Brownstein | Hyatt
Farber | Schreck

November 22, 2010

RE: OMEGA CHEMICAL CORPORATION – Operable Unit 2
EPA #: CAD042245001
Comment on Proposed Plan for the OU-2 Groundwater Contamination for the Omega
Superfund Site and the Omega Superfund Site Remedial Investigation/Feasibility Study

Figure 1. Scatter Plot of Simulated and Observed Water Levels, Excerpted from RI Report Figure K-10.

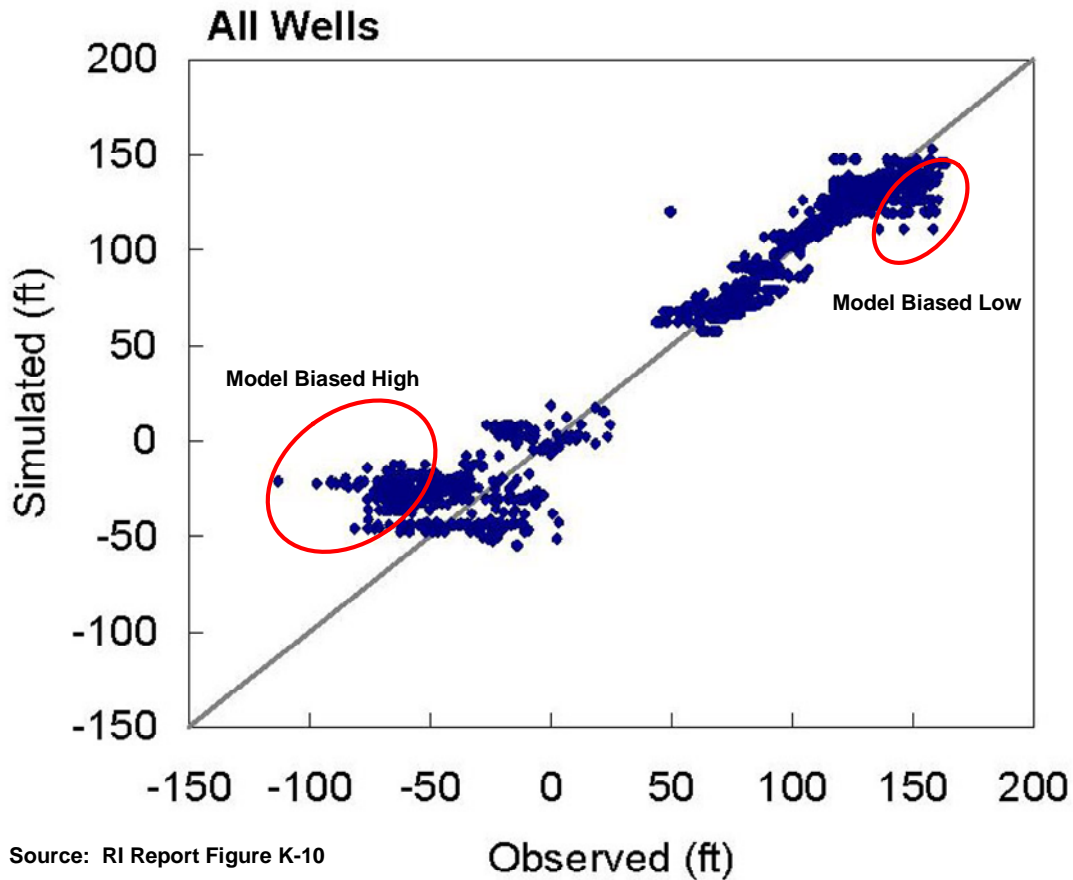
As noted in the circled areas in Figure 1, above, the magnitude of the bias in the model is commonly 20 feet or more in the highest and lowest heads in the model, effectively negating any downward vertical gradient.

Figure 2. Simulated and Observed Hydrographs, Excerpted from RI Report Figure K-12.

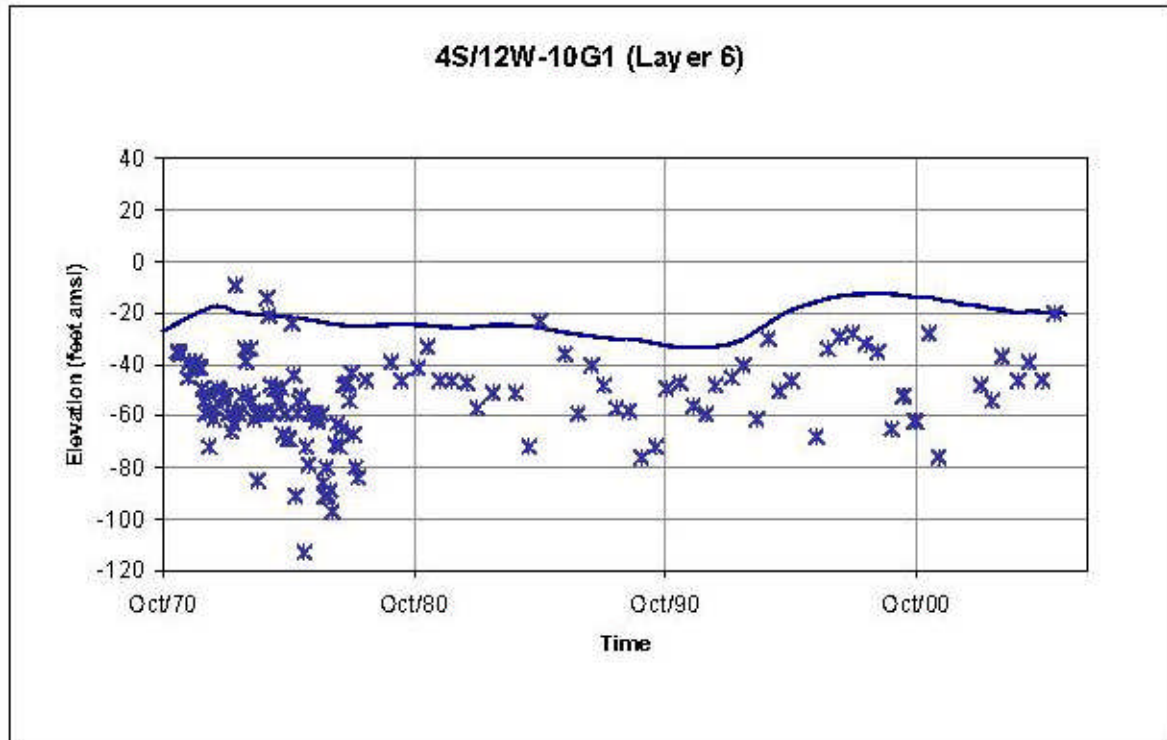
Another example of the bias in the modeled heads is shown in the transient calibration against observed hydrographs, an example of which is shown in Figure 2 below, from Figure K-12 of the RI Report:

Figure 3. Scatter Plot of Simulated and Observed Water Levels, Excerpted from FS Report Figure A-10

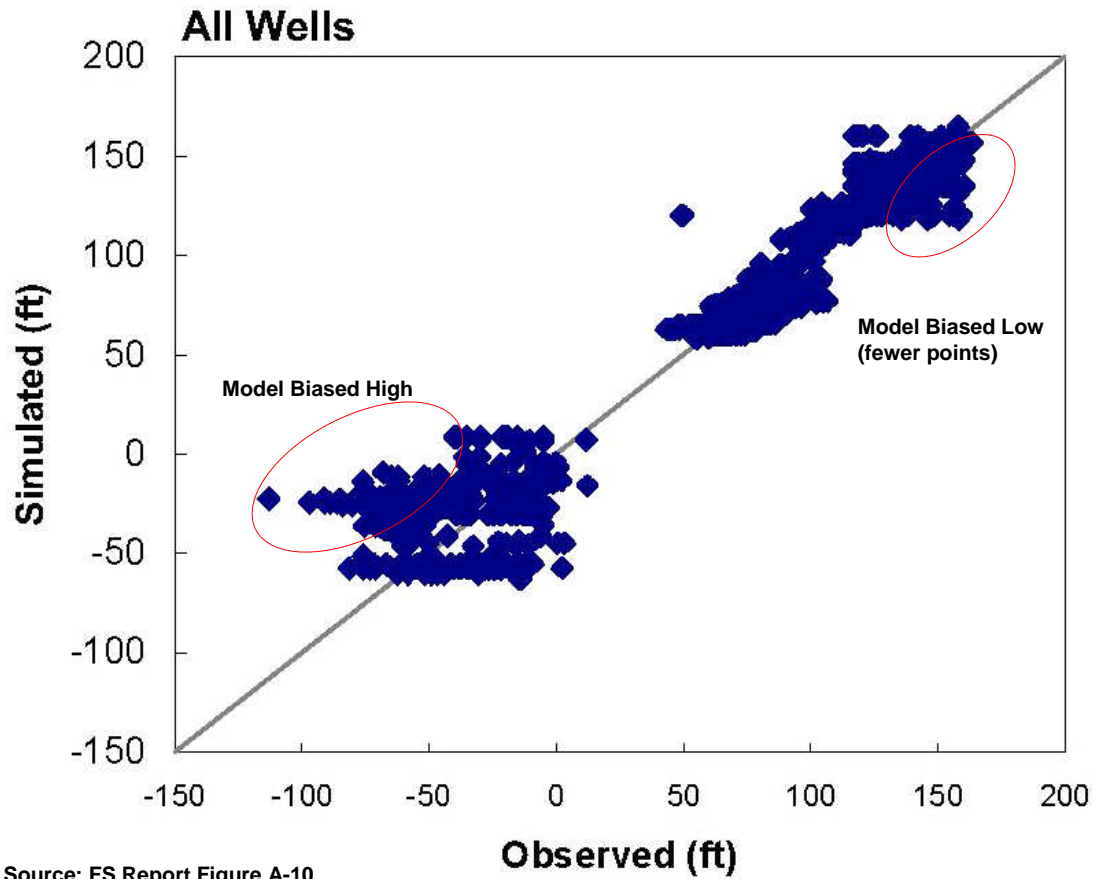
The refined groundwater model of the FS Report shows less bias in the simulated groundwater elevations, although there is still appreciable bias of the same kind shown in the RI model. The scatter plot from Figure A-10 of the FS Report is shown in Figure 3, below:

Figure 4. Simulated and Observed Hydrographs, Excerpted from FS Report Figure A-11.

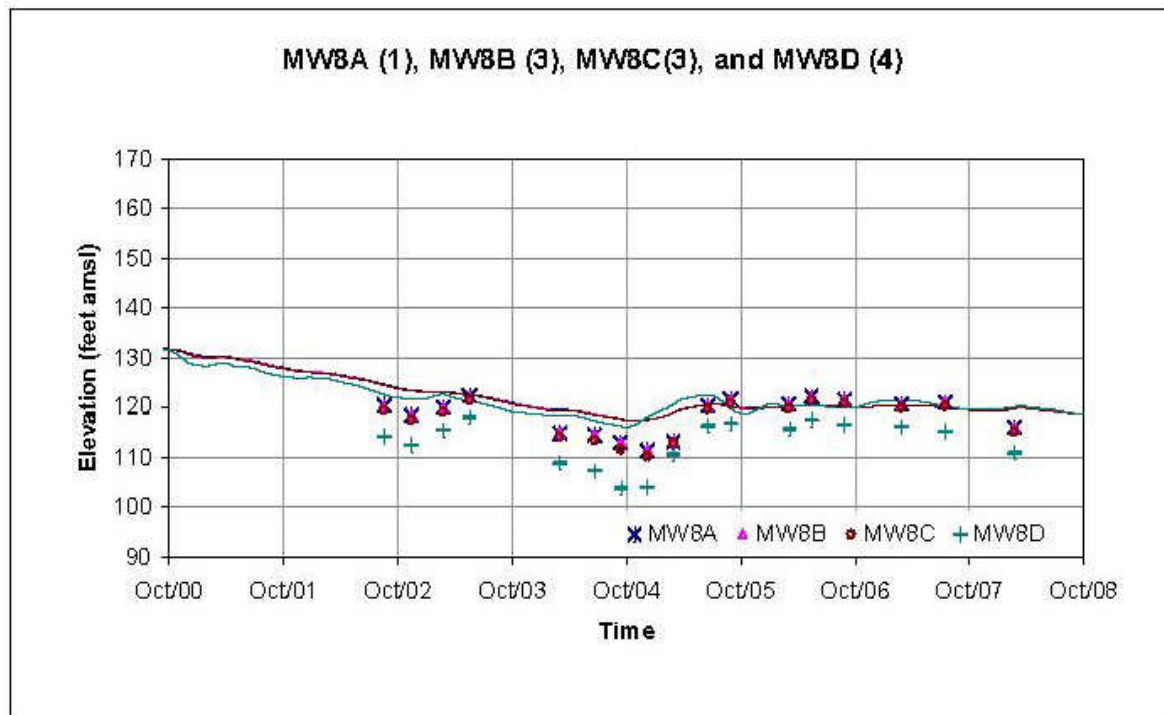
Similarly, the transient model hydrograph in the FS model still shows that while groundwater elevations in shallow units are generally well simulated, groundwater elevations in deep units are still simulated high, again under-representing the vertical hydraulic gradient. For example, the following transient calibration hydrograph (Figure 4) is from FS Report Figure A-11:

Figure 5. Time-Series Plot of TCE in the Pioneer 1 Well, Showing Breakthrough Curve for TCE.

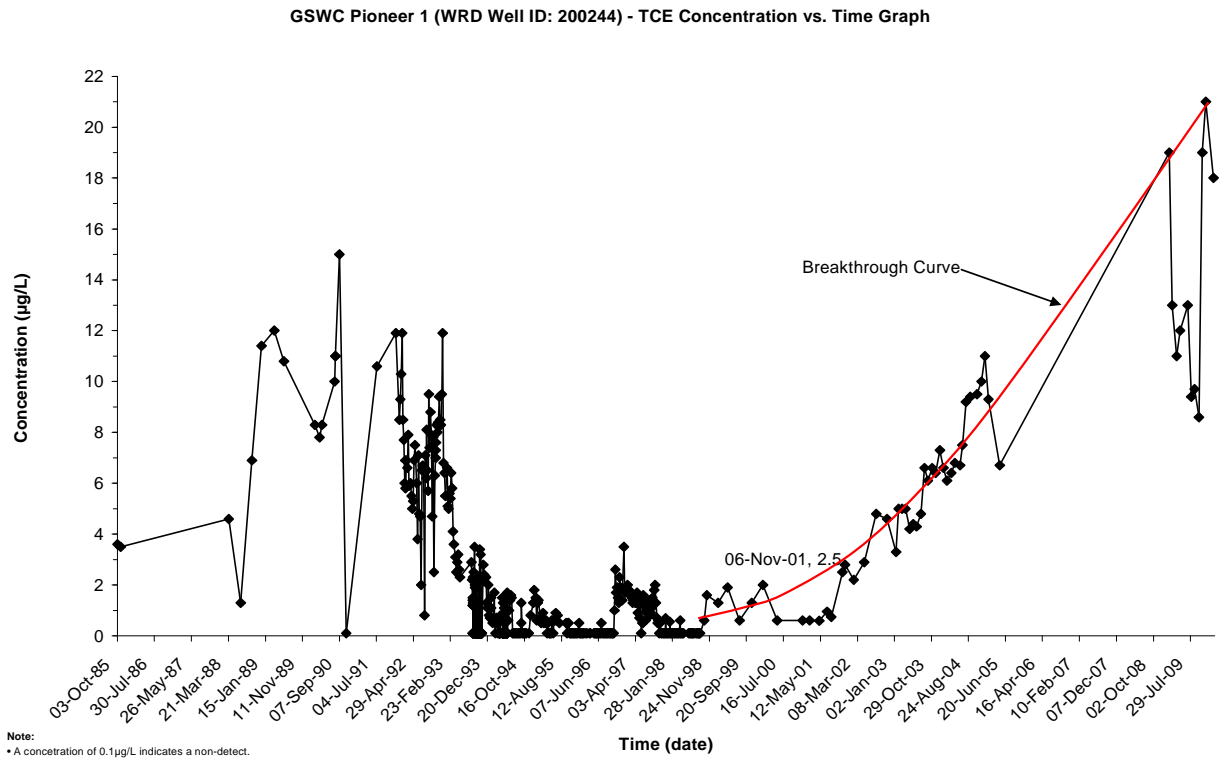
Another line of evidence that contamination in at least the Pioneer wells is from the Omega plume is the observed breakthrough of PCE and TCE at these wells. The breakthrough of TCE in the Pioneer 1 well is shown in the following time series plot (Figure 5):

The breakthrough of TCE in the well begins somewhere between late 1998 and late 2001, but is clearly in progress by November 2001. Pre-mid 1990's TCE appears to reflect a different regional plume that passed through the well from the mid 1980s until about 1996.

Figure 6. Time-Series Plot of TCE in the Pioneer 1 Well, Showing Breakthrough Curve for PCE.

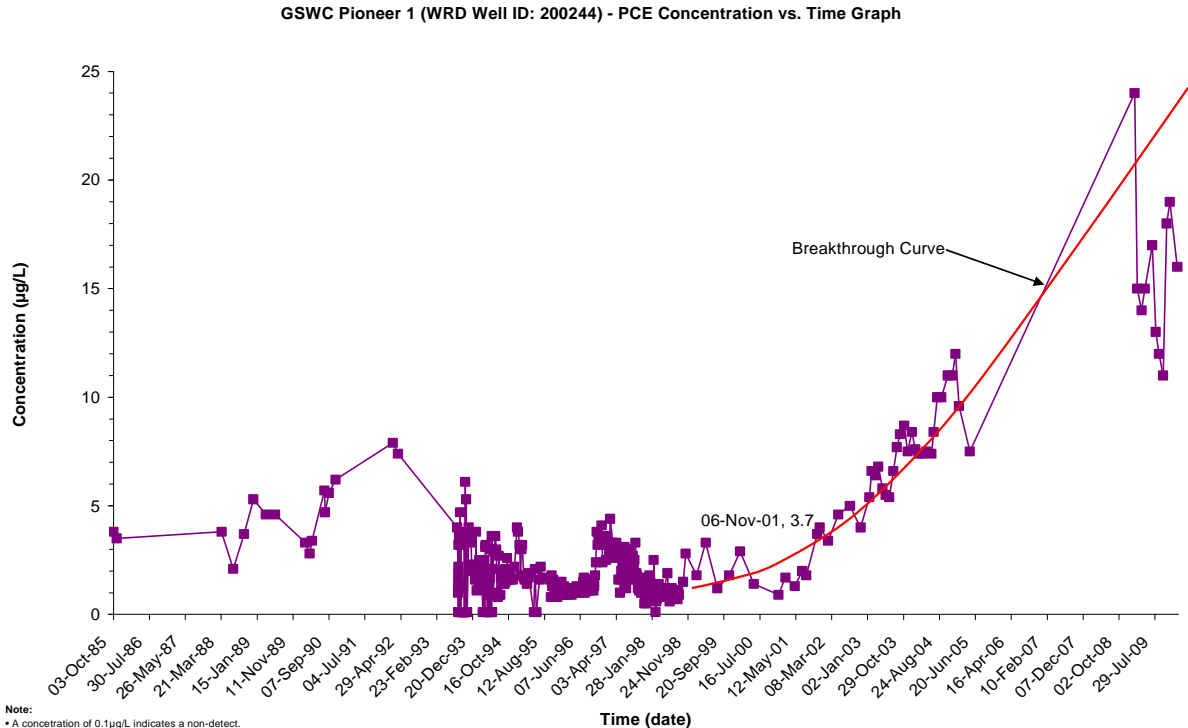
A similar pattern of breakthrough is observed for PCE in the Pioneer 1 well, as shown below (Figure 6):

Figure 7. Capture Zone Map, Pumping Scenario with Plume-wide Extraction, Excerpted from FS Report Figure A-14.

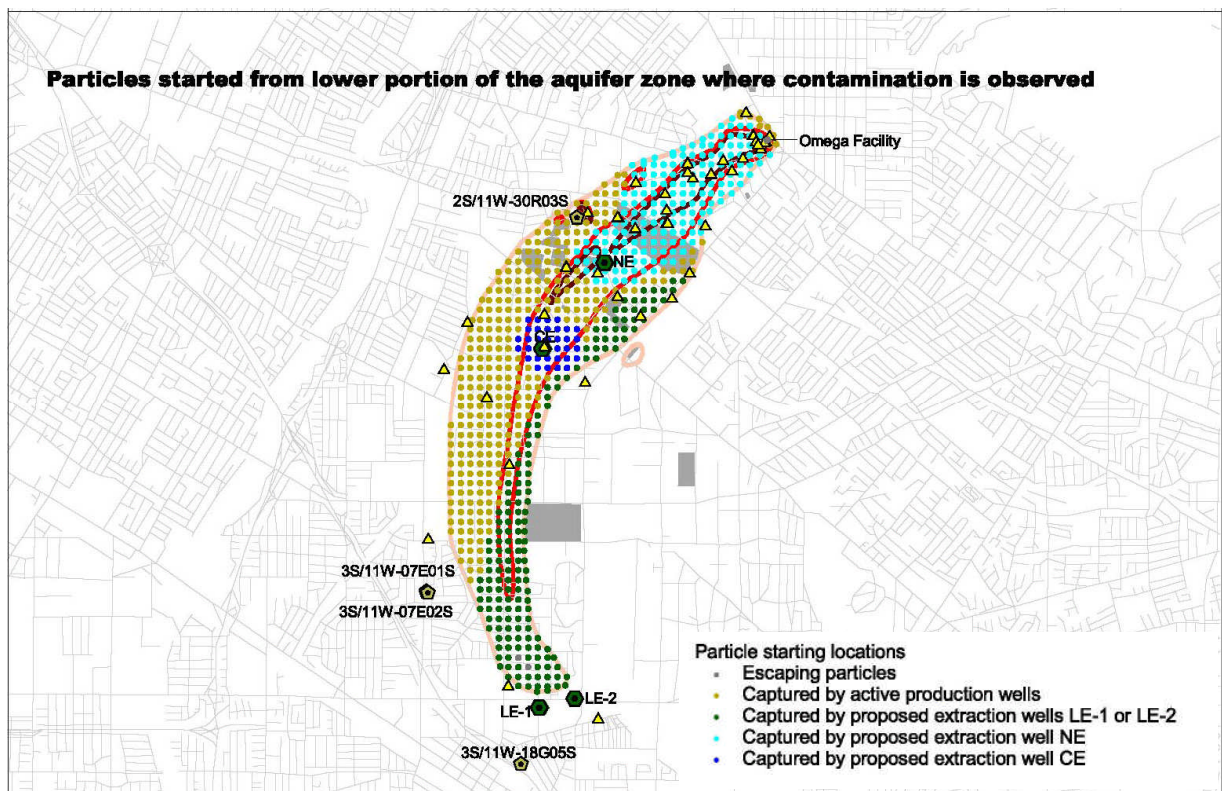
An example of the capture zone modeling results is shown in Figure 7 for the lower aquifer zone under plume-wide extraction (complete FS Figures A-13 and A-14 are included in Appendix B). All of the yellow-colored particles are captured mainly by the GSWC production wells.

The capture zone modeling indicates that very few particles escape capture by either the extraction wells or production wells, suggesting that either the leading edge or plume wide extraction alternative (including GSWC production wells) should be able to capture the entire OU2 plume.

Figure 8. Simulated PCE Plume After 5 Years of Pumping, Lower Aquifer Zone, Plume-wide Extraction Scenario, Excerpted from FS Report Figure A-17-3.

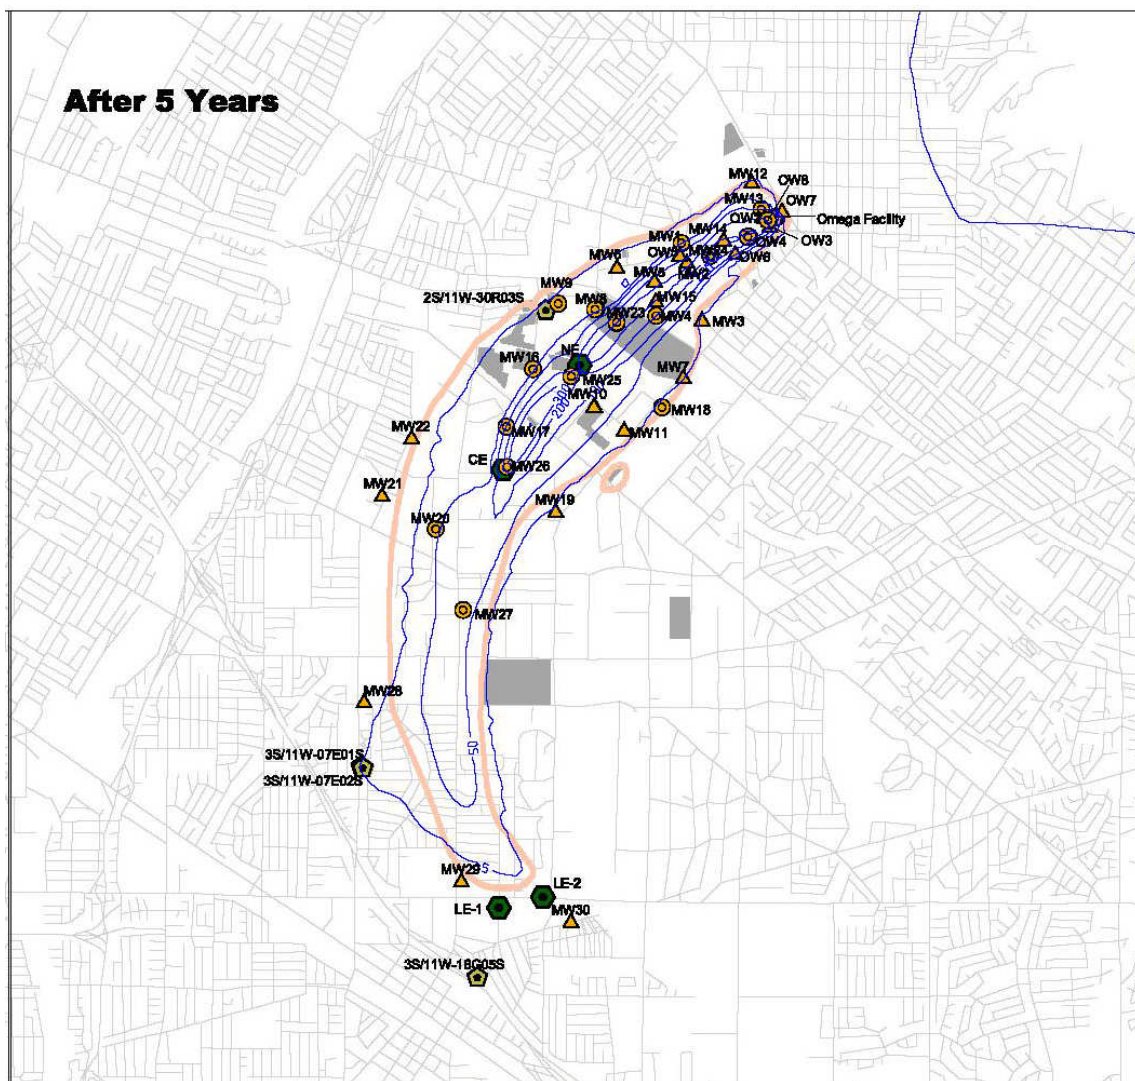
The capture zone simulations are supported by the solute transport modeling of remedial extraction alternatives (FS Report, Appendix A). The transport modeling shows that for all three remedial alternatives (i.e., no action, leading edge extraction, and plume-wide extraction), the plume in the “Lower Aquifer Zone” (again, terms are not defined in the FS Report) is intercepted by GSWC Pioneer 1 and 2 wells within five years after the start of extraction. In the “Middle Aquifer Zone,” the plume is intercepted by Pioneer 1 and 2 wells between 10 and 20 years after the start of extraction. Figures A17-2 and A-17-3 of the FS Report show the transport modeling results for the preferred plume-wide extraction alternative for the Middle and Deep Aquifer zones, respectively. The following Figure 8

shows the modeling results for the Deep Aquifer zone after five years of plume-wide extraction (from Figure A-17-3). Ironically, after five years of remediation extraction under the preferred alternative, the Deep Aquifer Zone plume is being intercepted by the GSWC wells, but not yet by the two leading edge extraction wells. USEPA should consider locating these wells further upgradient, so as to minimize the total volume of clean water pumped before they start to intercept the OU2 plume in excess of MCLs. It would also be appropriate to consider contingency locations (further downgradient) that reflect potential delays in system start-up.
